9 Oxford
Cherry Chase Villa of

STAFF ITEM

SUBJECT: Revision to approved HAWP (Case 35/13-13CC), for new construction at 9 Oxford Street, a vacant lot in the Chevy Chase Historic District

DATE: August 13, 2014

1 REAR ELEVATION
SCALE: 1/8"=1'-0"

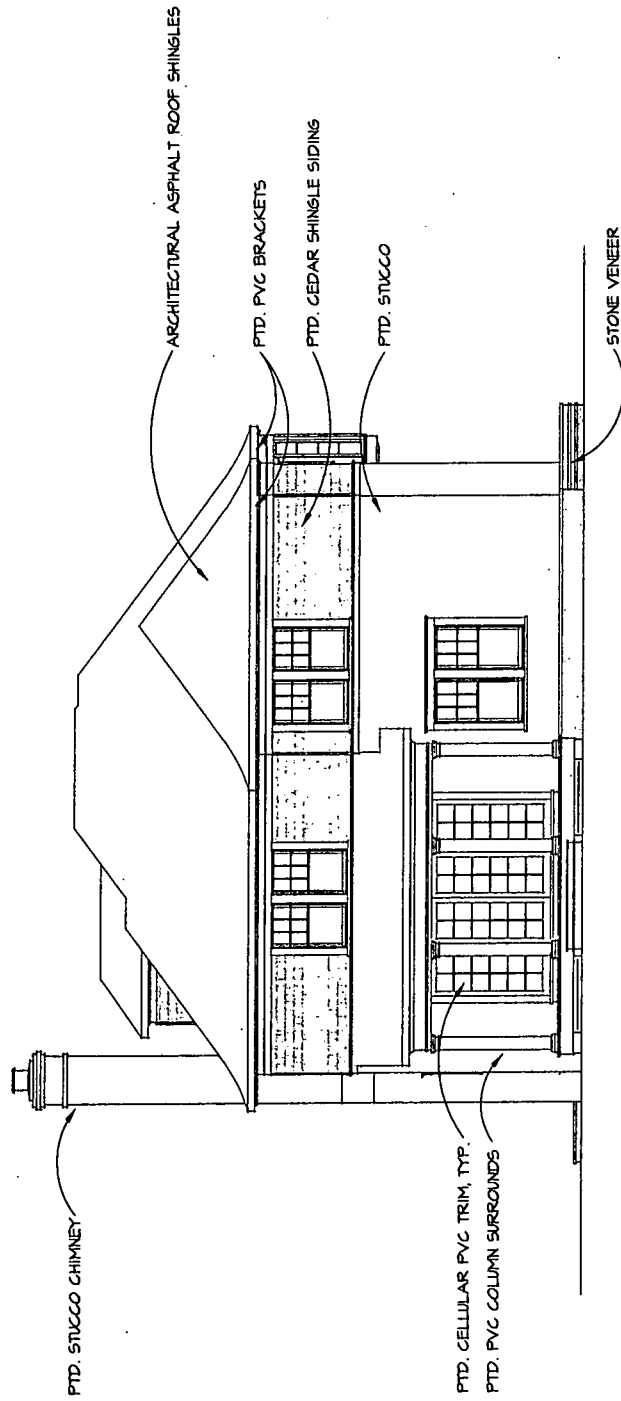
1. The applicants were approved to install a paired window in the second story, rear elevation. The applicants now propose to install a ganged set of three double-hung windows and one casement window in the second story rear elevation
2. The applicants were approved for a stacked pair of double hung windows on the rear elevation. The applicants now propose to a two story, three-side bay in the rear elevation with a single double hung window flanked by multi light windows on each story.

STAFF RECOMMENDATION: Staff finds this change to have no material effect on the historic resource and recommends the Commission approve this revision.
